PMT Modular HV Supply Design Status

December 2003
Madison Instrumentation Workshop

Action Items from May 03 PDR

PDR4: Coax negative margin

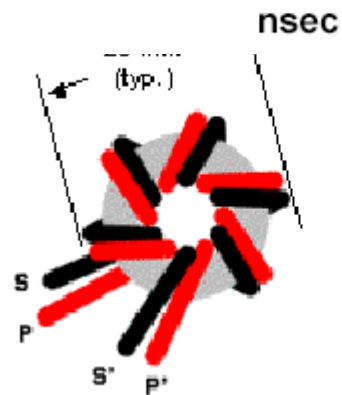
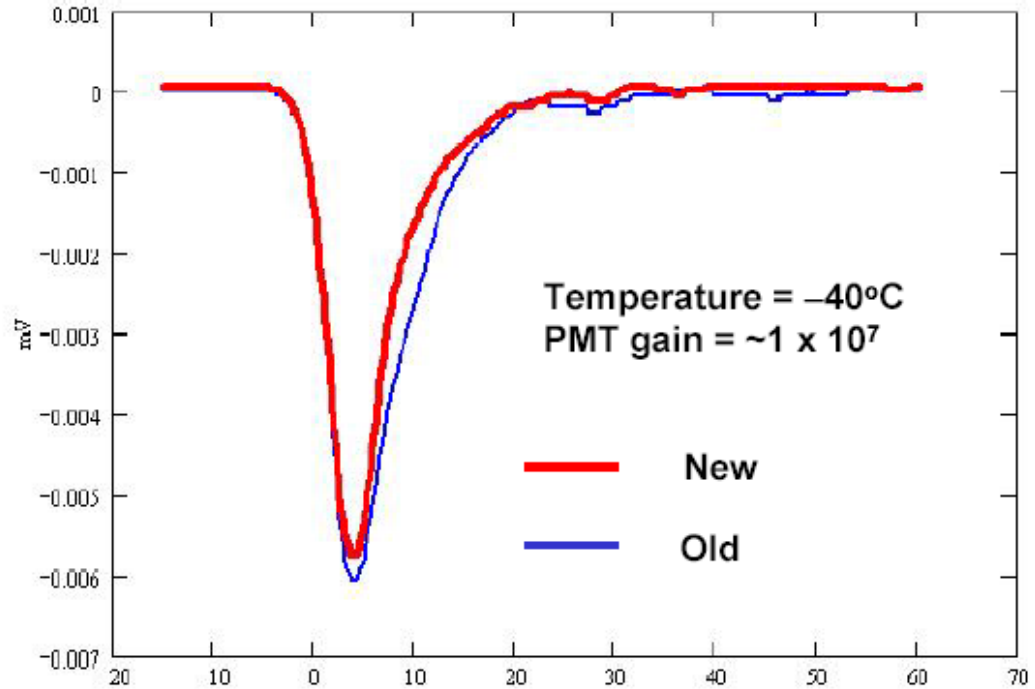
Old

New

10kV per wire
